**Re:** Arborist Review Tree Permit #2015-ARP-0015, Review and Recommendations  
**Site:** Scofield property, 4950 NE 184th St, Lake Forest Park, WA 98155

**ATTACHMENT: 2013 AERIAL SITE PHOTO**  
**4950 NE 184th St.**  
**Lake Forest Park, WA**

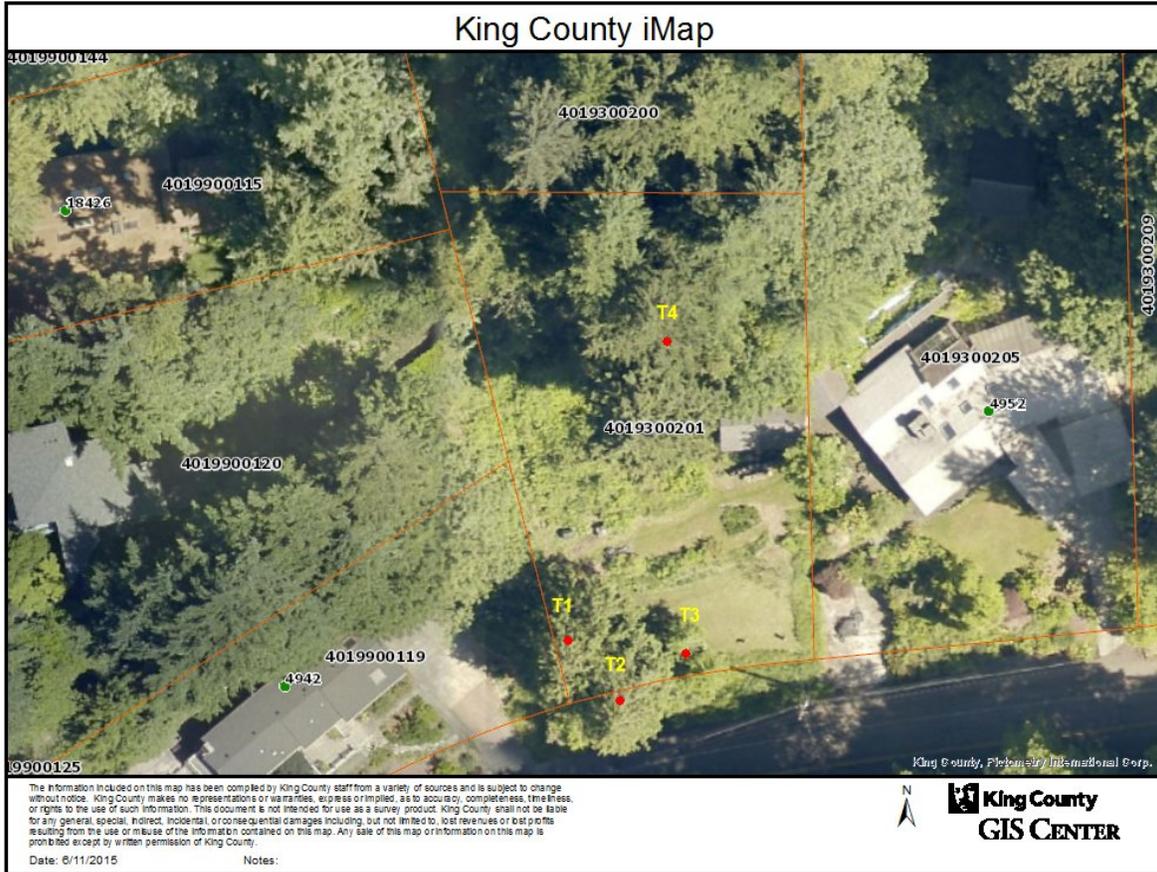
The proposed activity on this lot is for new construction of a single family residence. There are a total of 3-4 trees that potentially may be removal on the lot to allow the project to be completed as planned, refer to Site Plans and *Attachment: 2013 Aerial Site Photo*.

This is an undeveloped single-family residential lot, 14,329 square feet in size. The front south half of the lot is level grade and the back half of the lot is steep sloped terrain, see Site Plan. The tree canopy coverage goal for this size lot, pursuant to Chapters 16.14.080, is 39 % (5,588 sq. ft.). The current canopy coverage, from trees originating on the lot, is approximately 55.5% (7,955 sq. ft.), as determined either by collected tree data and/or interpretation of high resolution aerial photography, see *Attachment: 2013 Aerial Site Photo*.

- Tree 2 and Tree 3 are all within the proposed construction zone of the proposed project and are not suitable to retain and should be removed.
- Tree 1 has the potential to be retained. It is in generally good overall health and condition and is suitable to tolerate the proposed construction activities, provided the recommended tree protection measures are followed, see *Attachment: Tree Protection Measures*.
- Tree 4 is located in within the protected Sensitive Area, away from the proposed construction activities. It has the potential to be retained. It is in good overall health and condition. The assessed risk category for this tree is 'low', currently, and is likely to remain 'low' for the new developed residence, throughout the time frame for the tree risk assessment.
